Comments to the Canadian Environmental Assessment Agency and the Newfoundland and Labrador Department of Environment and Conservation with regards to the first 5 component studies for the Labrador-Island Transmission Link (ref # 10-03-51746 or 10-11-5036)

Preliminary comments on component reports submitted for the review of the Labrador-Island Transmission Link

June 12, 2012

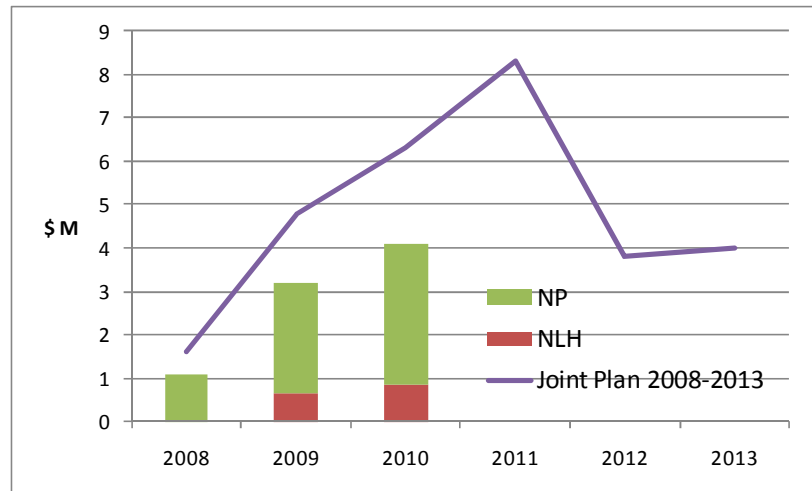
The Proponent states that “To date, the *response* to CDM programs and initiatives has been modest and lagging targets.”²¹ (emphasis added) However, it fails to point out that the **programs and initiatives themselves** have also been modest and lagging targets.

The following chart, drawn from my April 13, 2011 submission to the Joint Review Panel,²² demonstrates that CDM funding by NLH and by NP lagged far behind that which was projected in their Five-Year Joint CDM Plan.

This is not particularly surprising: Most utilities perform very poorly when they first begin to pursue CDM savings. What is surprising is that, based on its admittedly poor performance in the first years of its CDM program, **NLH has chosen to exclude consideration of CDM savings as a resource in its 50-year power plan.** I am not aware of any other utility in North America that has so blatantly disregarded CDM as a resource.

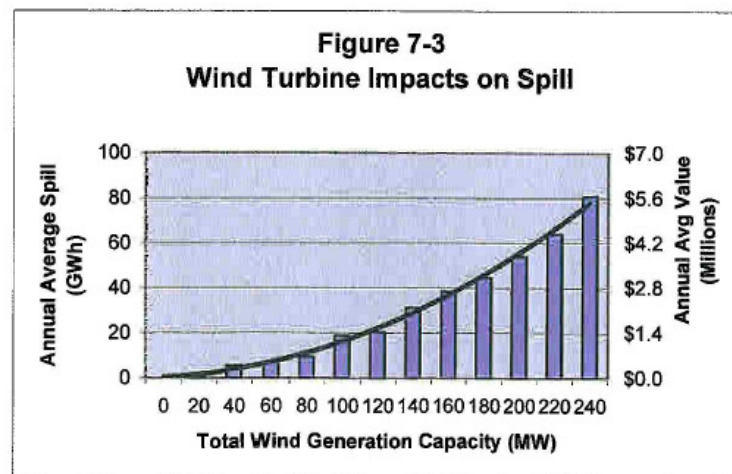
As for the limitations on wind power, the EIS indicates that they were established in a 2004 NLH study (*An Assessment of Limitations for Non-Dispatchable Generation f the Newfoundland Island System*), which was provided to the PUB as Exhibit 61.³¹ The EIS states that “The limits identified in the 2004 study are still applicable today.”³² This statement is misleading and factually incorrect.

The EIS states that the study “established two limits regarding the possible level of wind generation integration on the Isolated Island system, an economic limit and a maximum technical limit.”³³ The economic limit is that, in excess of 80 MW, “there would be a significant increase in the risk of spill at the hydroelectric reservoirs.”³⁴ The study notes that an additional 20 MW of wind power could result in an increase in expected spill from 9 to 19 GWh/yr, with a cost of

**Comparison of Revised and Sixth Plan Oil Price Forecasts
Refiners Acquisition Cost \$2010/barrel**

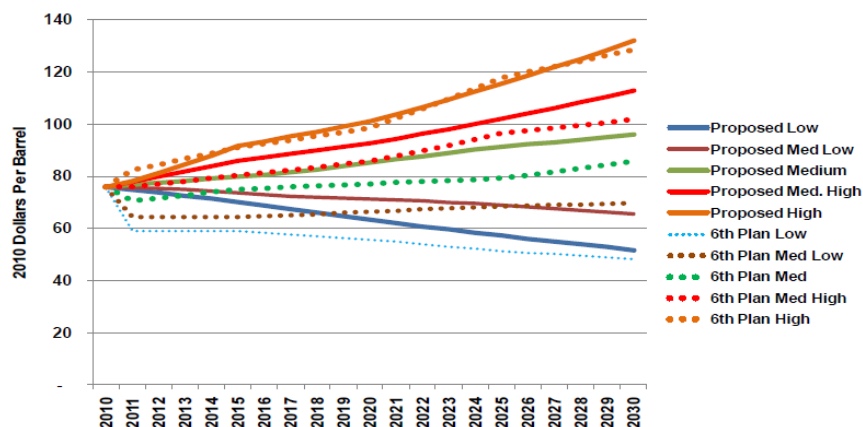
The PIRA high and low forecasts have not been made public, so to get an idea of the extent of the typical spreads between high and low oil price forecasts, I had to look to other sources. The following chart presents the oil price forecast from the Northwest Power Planning Council's 2009 Power Plan.

The high scenario shows prices more than twice as great as the low scenario (about \$130 versus about \$50 per barrel, in 2030). As MHI wrote in their report, long-term fuel price forecasts have a short shelf life.
